3 April 2015

MEMORANDUM

To: Bob Jaques, Seaside Basin Watermaster Technical Program Manager
From: Gus Yates, Senior Hydrologist, Todd Groundwater
Re: Peer Review of Seaside Basin Groundwater Modeling Studies

Figure 1. Basin Water Balance under Pre-Development Conditions

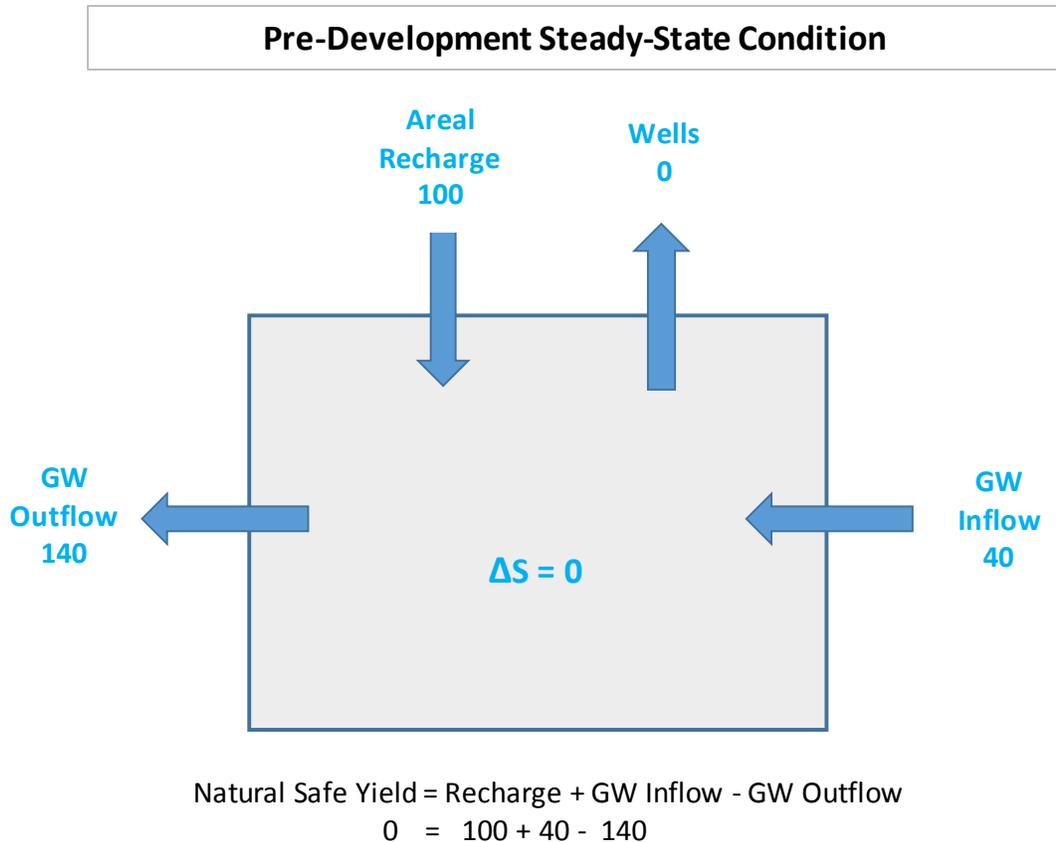
This is a partial water balance that omits pumping and storage change. Under pre-development conditions, pumping would have been zero and natural safe yield over a large number of years would also have been zero, because recharge plus groundwater inflow equal groundwater outflow under a condition of zero storage change. In fact, all undeveloped groundwater basins would have a natural safe yield of zero, which implies that there was no opportunity for groundwater development anywhere. The pre-development conditions are illustrated below in Figure 1, which shows a hypothetical water balance diagram.

Figure 2. Water Balance for Developed Basin

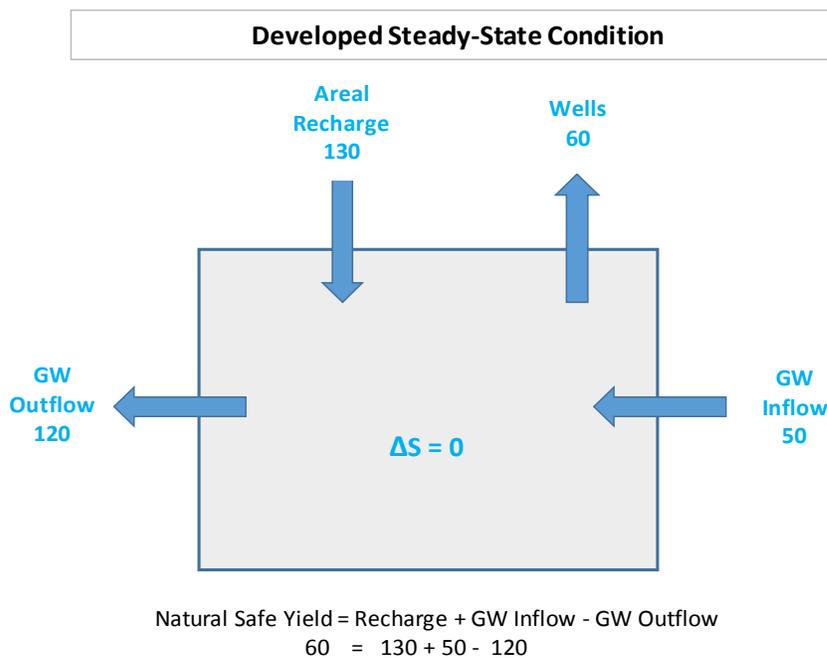
Following development, pumping changes the water balance, leading to an “unnatural” safe yield. This could also be a steady-state condition, where pumping is balanced by increased recharge, increased groundwater inflow and/or decreased groundwater outflow. This case is shown in **Figure 2**.

Notice that the natural safe yield exactly equals the amount of pumping. This is the result of increased recharge under developed conditions combined with head-dependent boundary responses to pumping (see below). Changing the amount of pumping can change the estimate of natural safe yield if pumping is balanced by changes in boundary flows.
